## Detailed Site Plan Harmony at Brandywine

## DSP-20014

STAFF REPORT

SUBJECT: Detailed Site Plan DSP-20014  
Type 2 Tree Conservation Plan TCP2-036-2020  
Harmony at Brandywine

# SITE PLAN

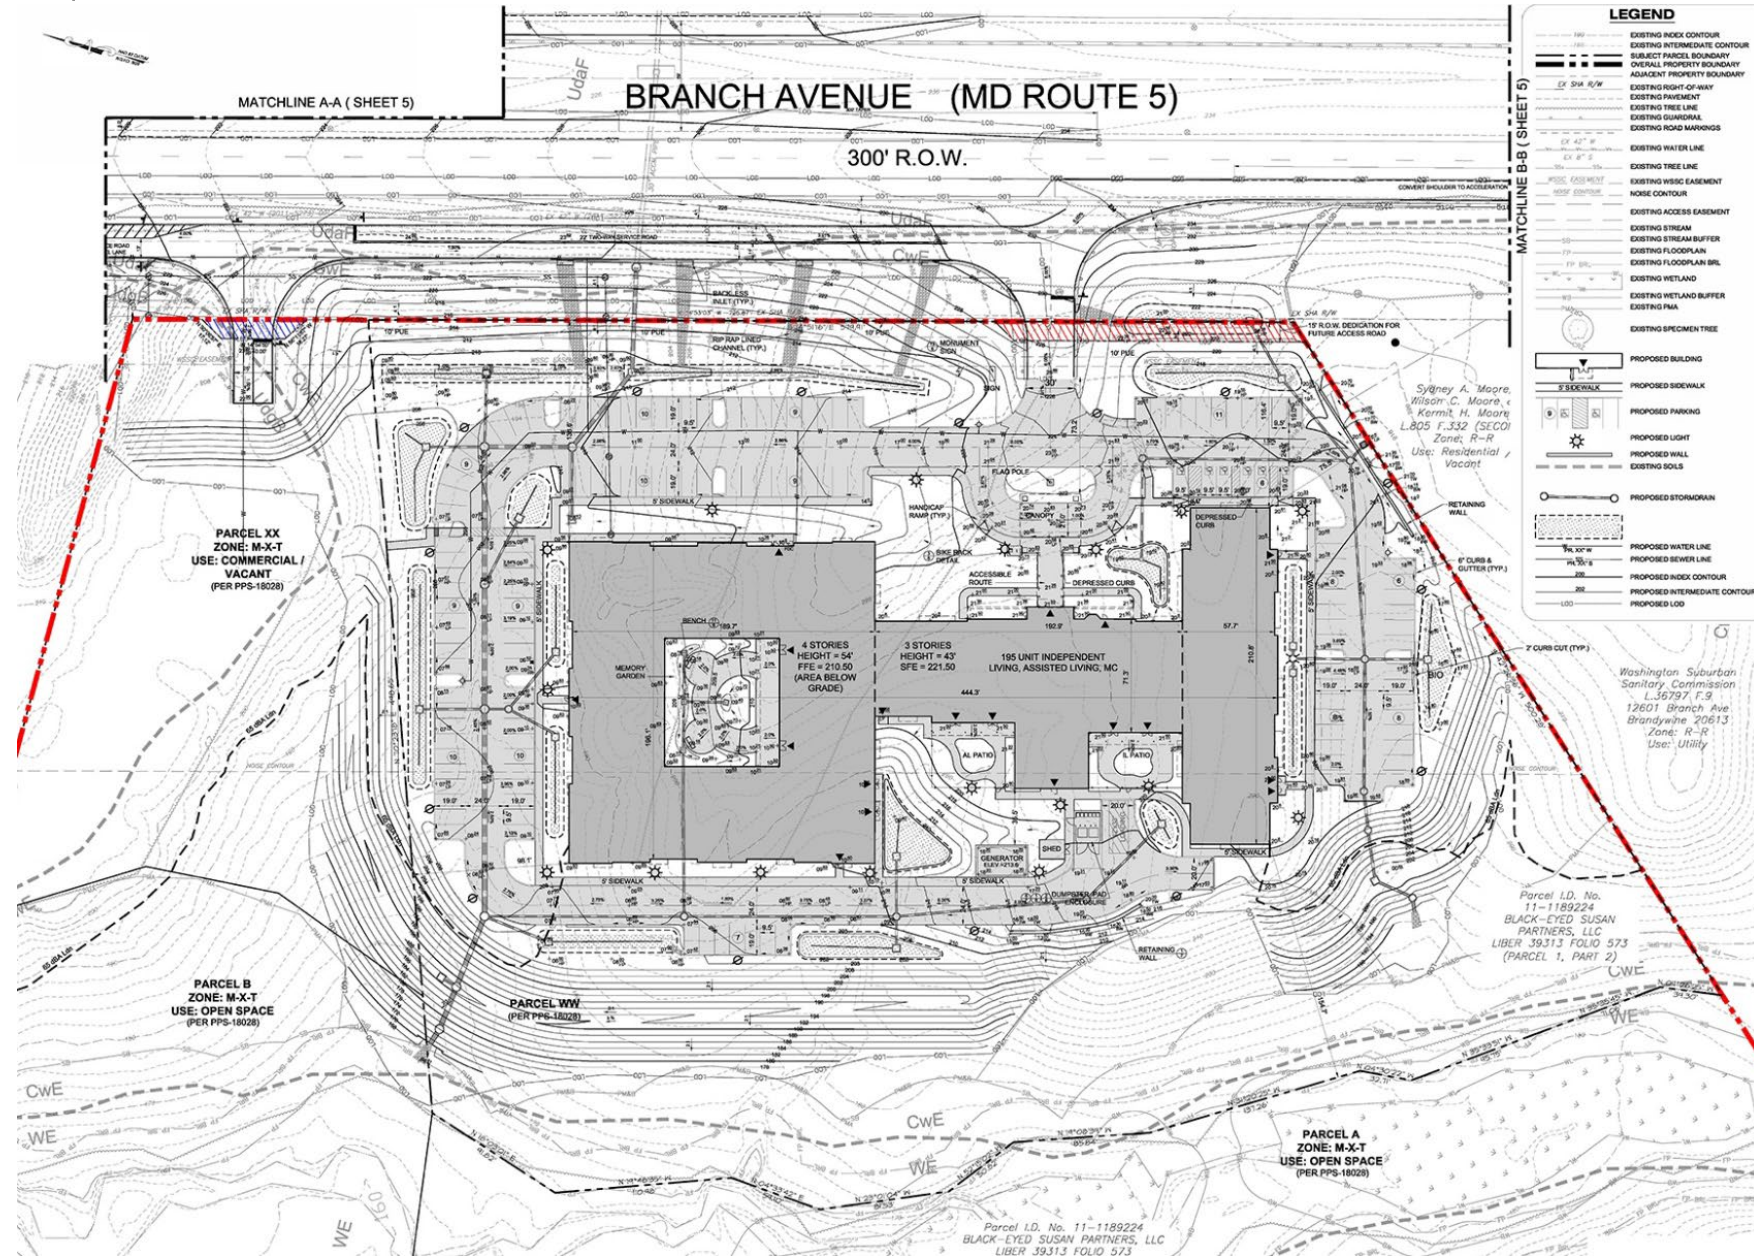
The project, as designed, does not encourage pedestrian activity. Staff recommends the installation of a sidewalk along the entire frontage on the MD 5 service road, which will connect this site with the adjacent commercial parcel to the north and planned master planned trail. Staff also finds that the pedestrian system is not convenient and comprehensively designed to encourage pedestrian activity within the development. Staff recommends a sidewalk be provided along the frontage of the service road with a

connection to the entrance of the building, to provide an Americans with Disabilities Act accessible route to the future development of the adjacent property to the north. These facilities will provide for a convenient and comprehensive pedestrian system.

- e. Provide landscaping at the base of the freestanding sign to provide seasonal interest.
- f. Provide a standard minimum five-foot-wide sidewalk, and associated crosswalks and Americans with Disabilities Act curbs ramps, along the service road to connect the subject site and the adjacent parcel to the north, unless modified by the Maryland Department of Transportation State Highway Administration with written correspondence. Provide a sidewalk connecting to the building entrance from the service road sidewalk.

12 MONUMENT SIGNAGE DETAILS  
6 SCALE: NTS

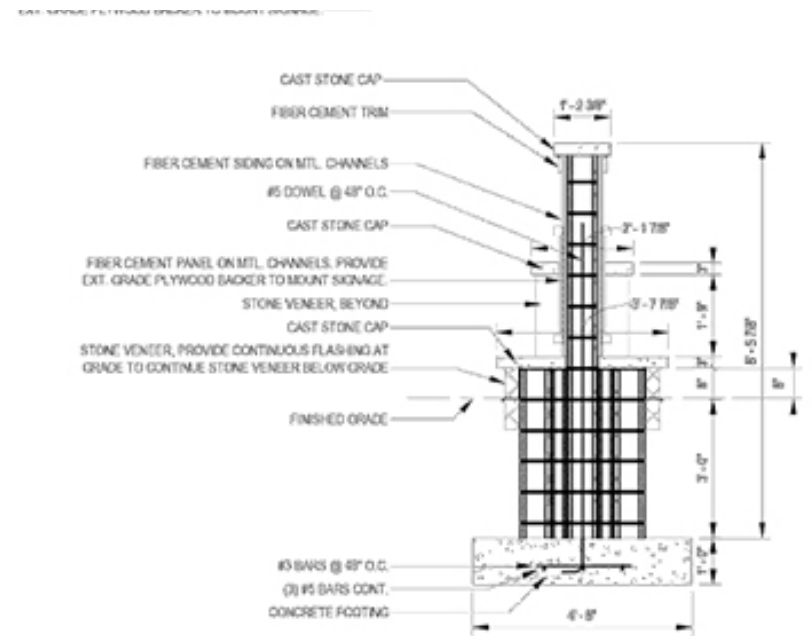
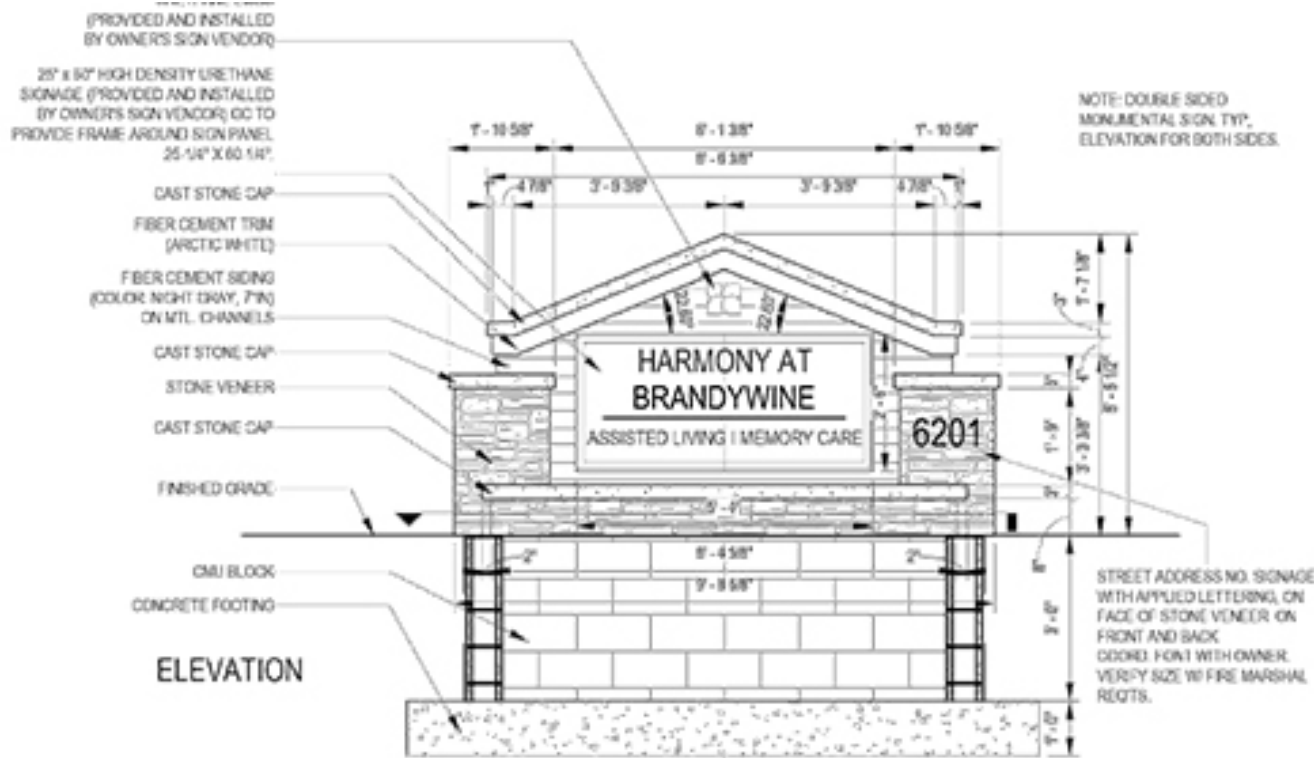
The DSP proposes one approximately six-foot-high, double-faced, freestanding sign at the entrance to the facility from MD 5; no building-mounted signs are proposed. The freestanding sign includes a signage panel that is mounted on a stone veneer base with a gabled cast stone cap. The signs include the logo and channel letters displaying the name of the rehabilitation center. It is noted that the freestanding sign does not include landscaping at its base and has been conditioned herein, to be added to provide seasonal interest.
